SCDC Role in the former Bayersite Works

South
Cambridgeshire
District Council

Planning Updates

Planning Updates – Frequency of Groundwater Level Monitoring (Condition 4)

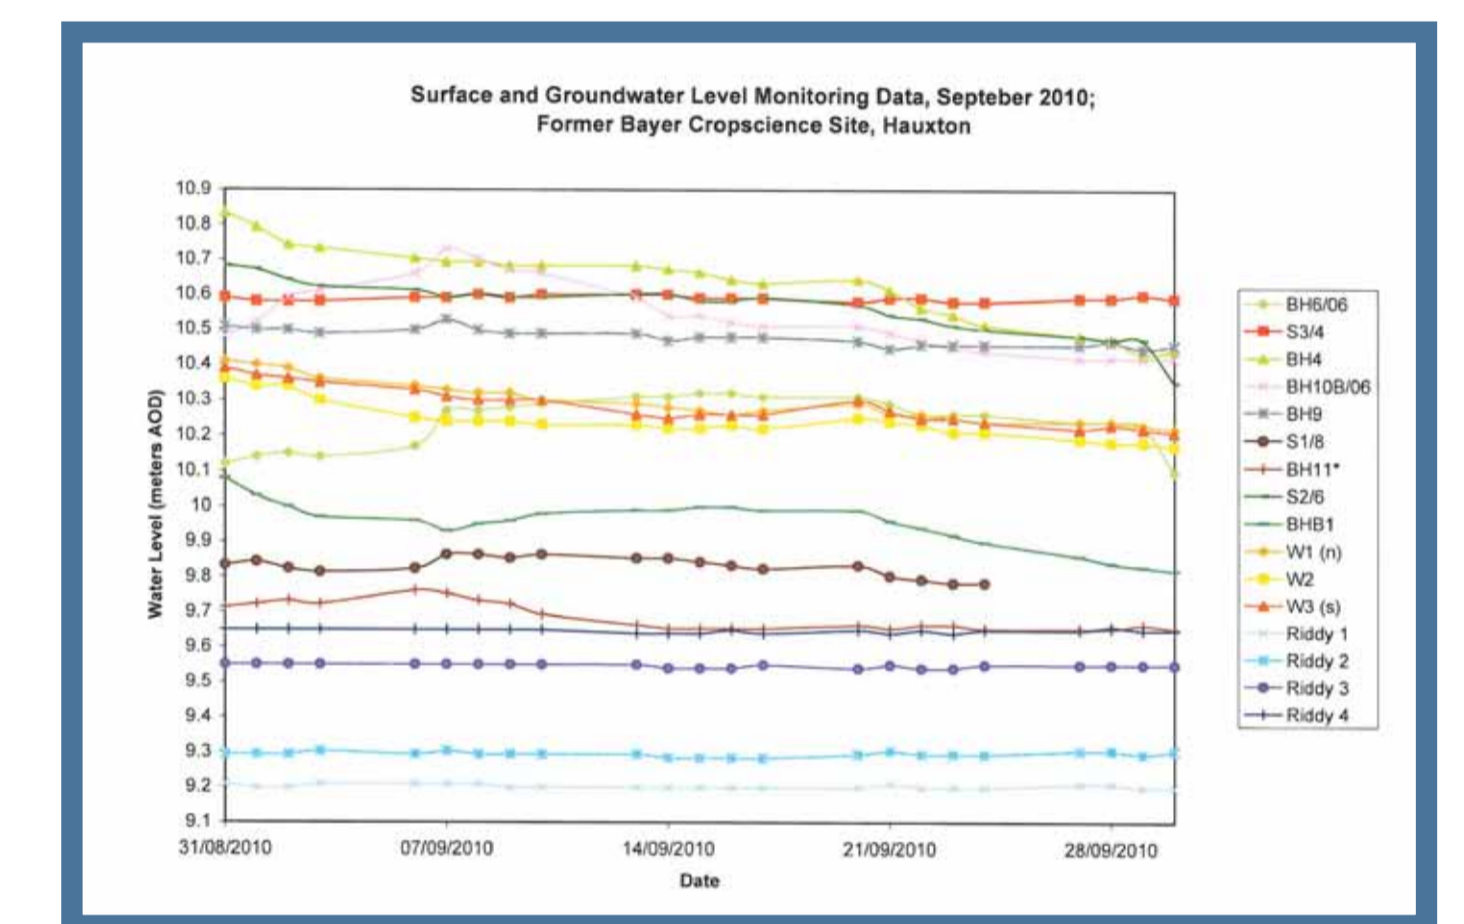
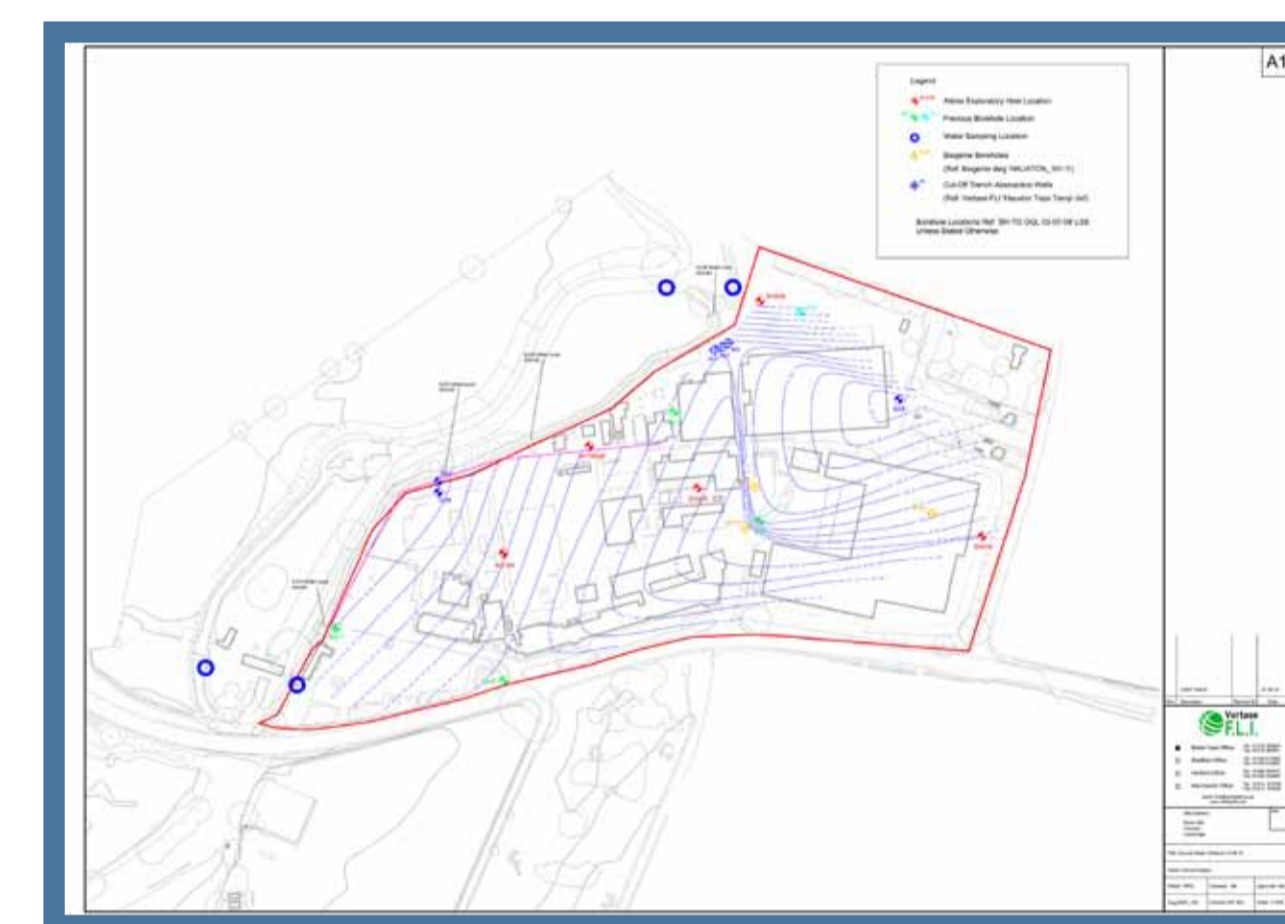
Why does the frequency need to be changed?

It was envisaged from prior ground investigation works that a significant amount of groundwater was present on site that would require monitoring to ensure that remediation works on site caused no issues or impact to the adjacent water courses.

Since starting the remediation works, it is apparent that there is not a significant water body on site.

Measurements of the depth of groundwater across the site were being taken daily. A variation to Condition 4 and the Remediation Method Statement has been made to reduce the frequency of monitoring to twice weekly unless a rainfall event greater than 6mm in a 24 hour period occurs in which case the levels will be monitored twice within the following 3 days.

Condition 4 of the remediation consent also required that weekly groundwater level contour maps were provided in the monthly report. This has now been changed to graphs to allow a clearer comparison of changes in groundwater level.
